## **Popeyes Louisiana Kitchen**

Design & Construction Field Bulletin	
Date	May 2, 2016 (Issuance #001)
Field Bulletin No.	FB-004 2016 (1 pages)
Category	Mechanical
Subject	Captive Aire Hood Ansul Discharge Piping & Nozzles
Prototype Set Referenced	PLK 15 Series Drawings
Prototype Drawings Referenced	Captive Aire Sheet 3/M3
D&C Contact	design@popeyes.com

## **Correct Installation**

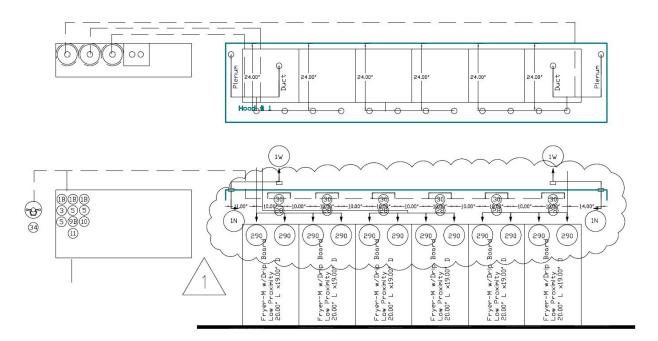
All the fryer vats should fall within the protected area of the Ansul system above. Fire inspections are being failed because of inadequate coverage.

Refer to the following drawing to ensure that the correct installation of the nozzles.
